Rezoning Transportation Analysis

Petition Number: Insert Zoning Petition #2021-023

General Location Identifier: Tax IDs: 22327148, 22327149, 22327150, 22327151, 22327152

Date	Description
02-25-2021	First Review (LJ)
03-25-2021	Second Review (LJ)
04-28-2021	Third Review (WB)

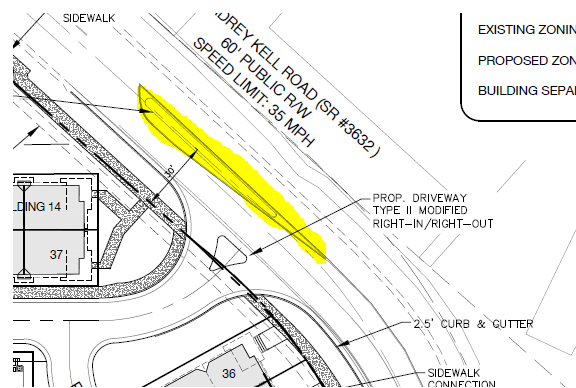
1. ~~**Curbline:** The proposed zoning district has a setback measured from back of the existing or proposed future curbline.~~
 - a. **Resolved (03/18/2021): Marvin Road (NCDOT):** The future location of back of curb and gutter is 27' from the Marvin Road centerline. Label and dimension the curb and gutter from the centerline for each road on the site plan.

- b. **Resolved (03/18/2021): Old Ardrey Kell Road (NCDOT):** Location of curb and gutter is in its existing location.

Label and dimension the curb and gutter from the centerline for each road on the site plan.
